# South Ford and Gualan Environmental Impact Assessment Screening and Scoping Report Addendum

## Draft Report

December 2023

**Figure 3-2 Liniclate Flood Protection Bund cross section**

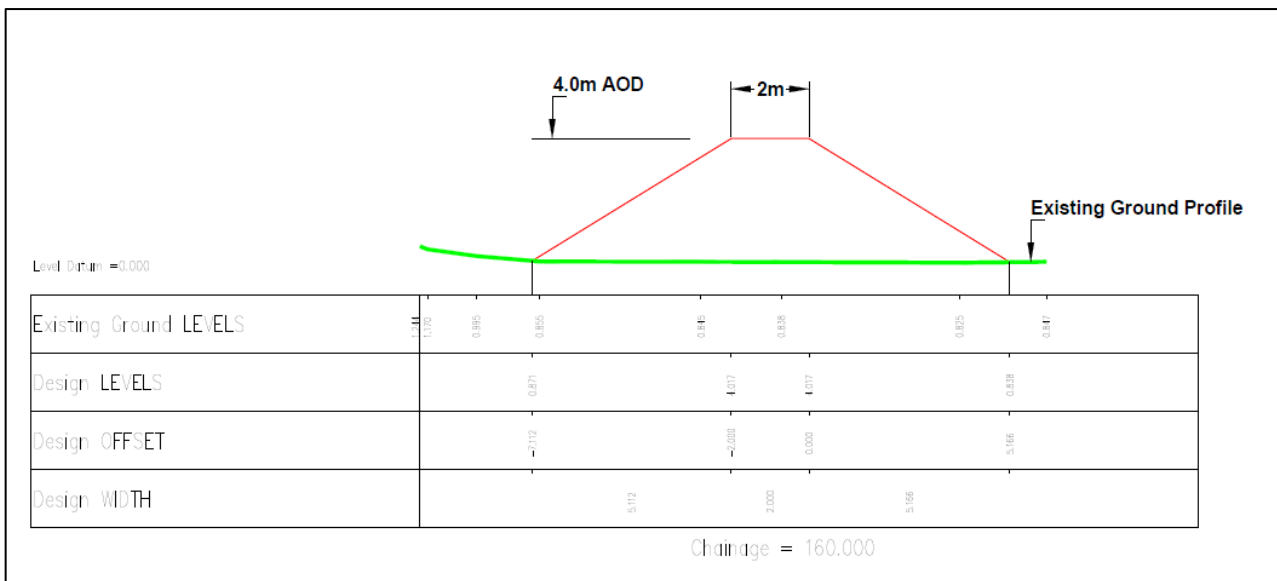
- 3.2.5 The bund itself would be constructed from a mix of imported rockfill and sand with the top vegetated machair layer within the footprint of the bund stripped and used to dress the surface of the bund (with additional seeding and planting as necessary). The detailed arrangement of the rock core, impermeable membranes, pipes, and flap valves has yet to be decided.
- 3.2.6 Figure 3-2 shows additional design for the Liniclate Flood Protection Bund cross section.

**Figure 3-4 Liniclate Flood Protection Bund long section extract.**

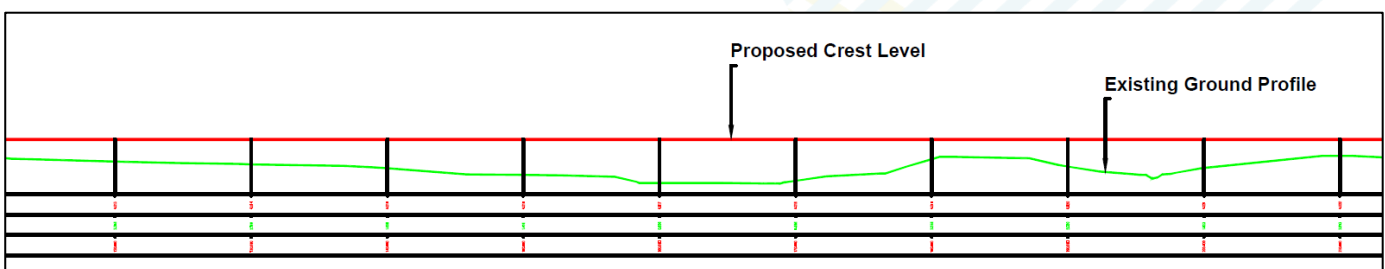
- 3.2.7 Figure 3-3 shows additional design for the Liniclate Flood Protection Bund long section. Due to the size of the designs, please refer to Appendix A for the full details.
- 3.2.8 Figure 3-4 shows a key extract Liniclate Flood Protection Bund long section demonstrating the proposed crest level compared to the existing ground profile at the approximate midpoint of the bund.
